Contract #: 04-0120F4Cty: SF/ALA Rte: 80 PM: 13.2/13.9File #: 69.25B**QUALITY ASSURANCE -- NON-CONFORMANCE REPORT****Location:** Changxing Island, Shanghai, P.R. China**Report No:** NCR-000892**Prime Contractor:** American Bridge/Fluor Enterprises, a JV**Date:** 13-Nov-2010**Submitting Contractor:** Zhenhua Port Machinery Company, Ltd (ZPMC), Changxing Island**NCR #:** ZPMC-0854**Type of problem:**

Reference Description: QA found 2 missed UT indications after ZPMC had tested and accepted the weld at Segment 11AW countweight connection plate

Subject: NCR No. ZPMC-0854

Job Name: SAS Superstructure

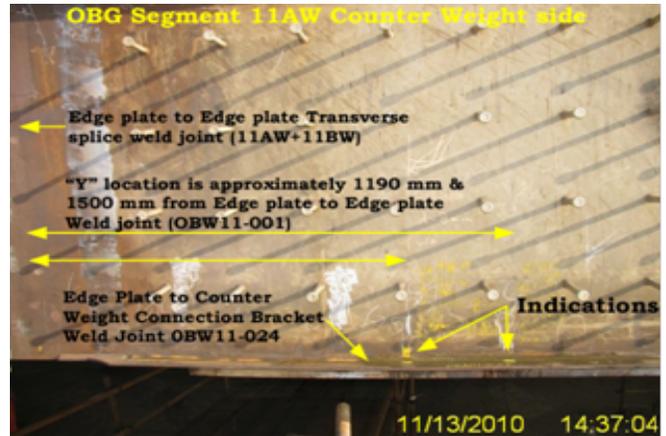
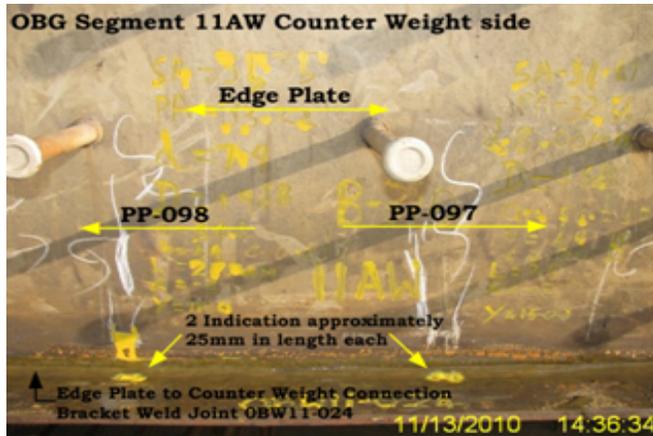
During the Quality Assurance (QA) Ultrasonic Testing (UT) review of welds located on Orthotropic Box Girder (OBG) Segment 11AW, this QA Inspector discovered the following issues:

- Two (2) Class "A" longitudinal linear indication measuring approximately 25mm in length each.
- The indications dB rating are +9dB, and +6dB.
- The thickness of the plate is 10 mm; the depth of both of the indications is approximately 8 mm.

- Both indications are located on the weld joint identified as OBW11-024.
- The weld is a Complete Joint Penetration (CJP) corner joint joining Edge Plate to Counter Weight Connection Bracket.

- The "Y" location for these indications is approximately 1190 mm & 1500 mm from Edge plate to Edge plate Transverse splice Weld joint (OBW11-001).
- The Notice of Witness Inspection (NWIT) No. is 007333. The indication is located within the area previously tested and accepted by ZPMC Quality Control (QC) personnel. As per the contract documents, ZPMC's QC personnel are required to 100% UT inspection of this weld.

Reference Resolution: ZPMC has removed, and repaired the indication and has performed NDT on the area to ensure that the defects were removed

The proposed resolution is acceptable. This NCR is considered closed.

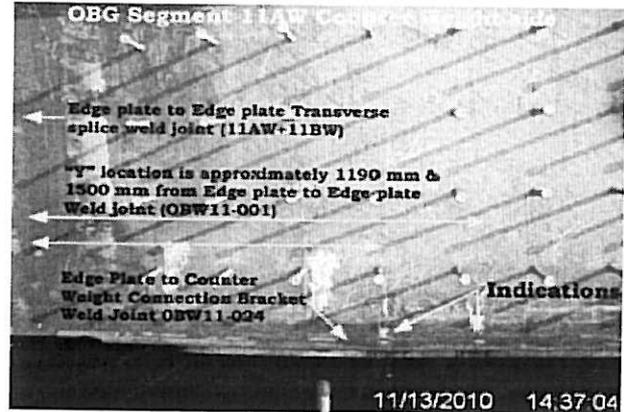
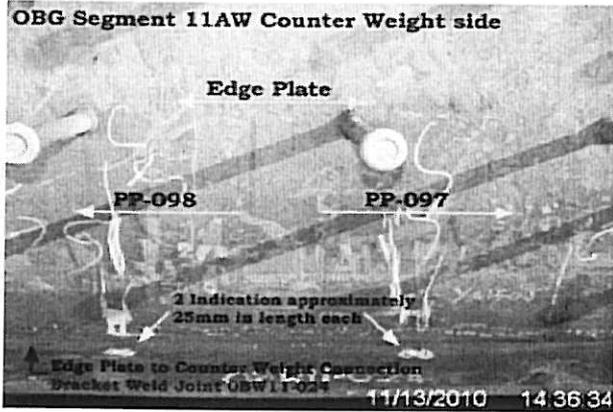
During the Quality Assurance (QA) Ultrasonic Testing (UT) review of welds located on Orthotropic Box Girder (OBG) Segment 11AW, Caltrans QA Inspector discovered the following issues:

- Two (2) Class "A" longitudinal linear indication measuring approximately 25mm in length each.
- The indications dB rating are +9dB, and +6dB.
- The thickness of the plate is 10 mm; the depth of both of the indications is approximately 8 mm.

- Both indications are located on the weld joint identified as OBW11-024.
- The weld is a Complete Joint Penetration (CJP) corner joint joining Edge Plate to Counter Weight Connection Bracket.

- The "Y" location for these indications is approximately 1190 mm & 1500 mm from Edge plate to Edge plate Transverse splice Weld joint (OBW11-001).
- The Notice of Witness Inspection (NWIT) No. is 007333. The indication is located within the area previously tested and accepted by ZPMC Quality Control (QC) personnel. As per the contract documents, ZPMC's QC personnel are required to 100% UT inspection of this weld.
